RUD34

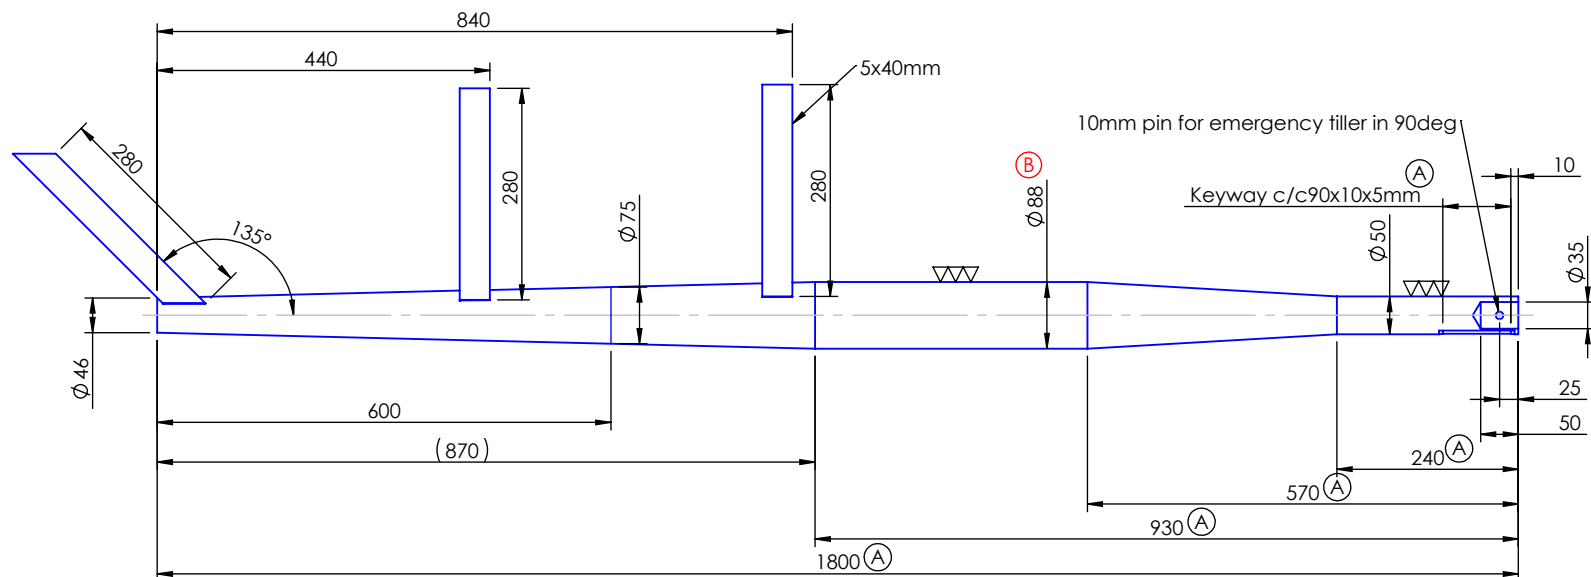
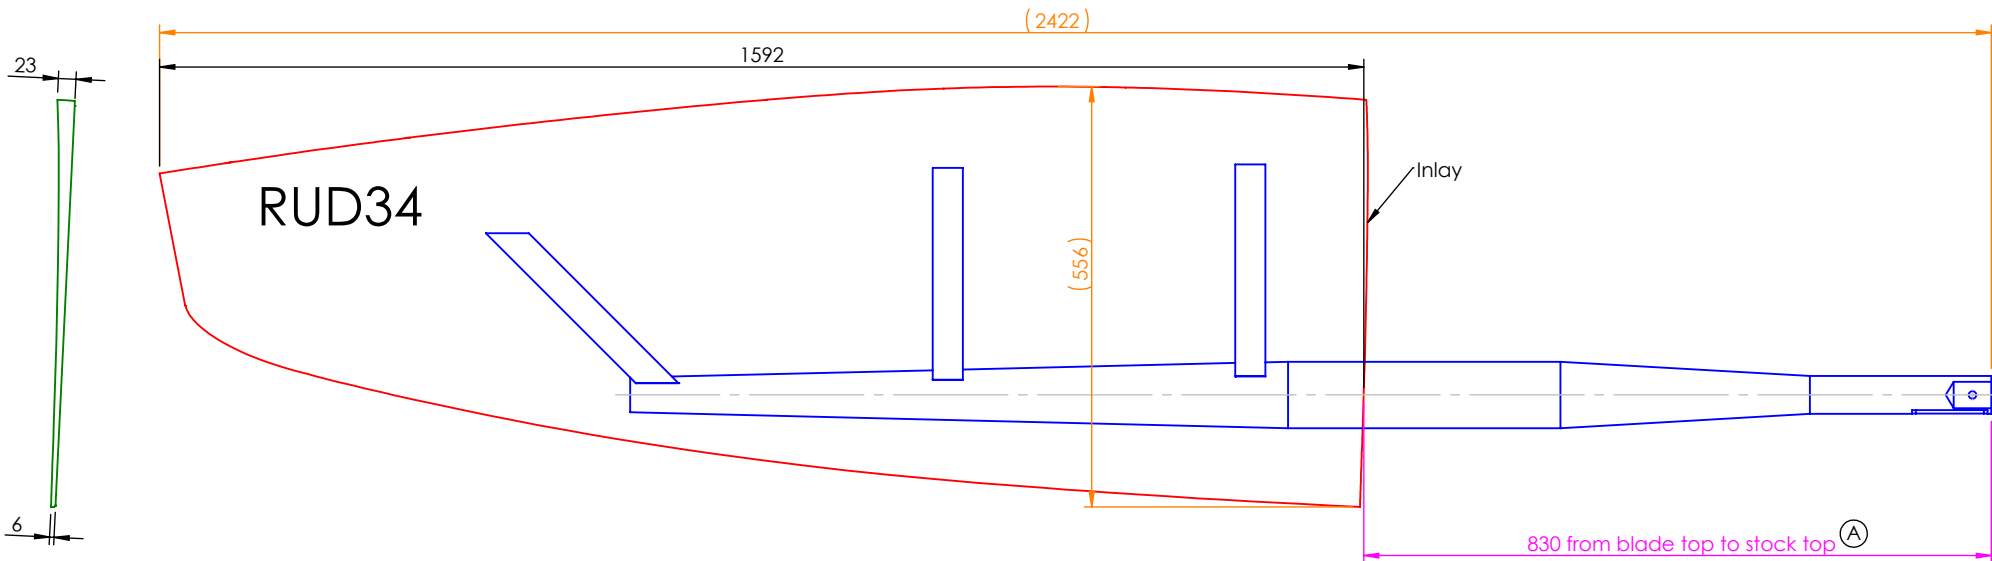
REVISIONS				Project	Product Name:	Filename		
Rev.	Description	Date	Author	Swan 55	Rudder	Swan 55 rudder rev. B		
A	Stock made 20mm longer, keyway made 20mm longer	09-09-2021	TCH	Jefa Rudder S Y S T E M S JEFA MARINE A/S NIMBUSVEJ 2 2670 GREVE. DENMARK Tlf: +45 4615 5210 Email: info@jefa.dk www.jefa.dk	Drawing no. SW44760 (B)	Sheet: 1 of 1	Proj. method:	
B	Mat. changed to Alu, dia changed to Ø88 was Ø68, new part no. created.	24-10-2022	TCH		Material: Alu 6082 (B)	Scale: 1:10	Format: A4	CAD-System: SolidWorks
					Creation Date: 24-06-2021	Dimensions are given in mm. Dimensions without tolerances according to DS/ISO 2768-m.		
					Author: Thor	This drawing belongs to Jefa Marine A/S and may not be used or shown without permission.
